Bus loop crosswalk on Excalibur Rd

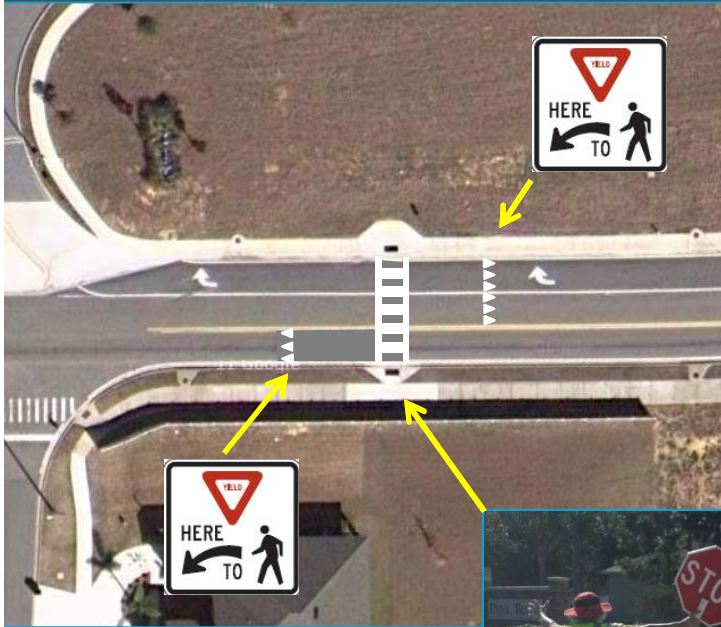
- ✓ Crosswalk on Excalibur Rd adjacent to bus loop should still be enhanced with ladder style high visibility markings, warning signs, advance yield lines, and yield to pedestrians signs
- ✓ Crossing guard can be used in place of RRFBs
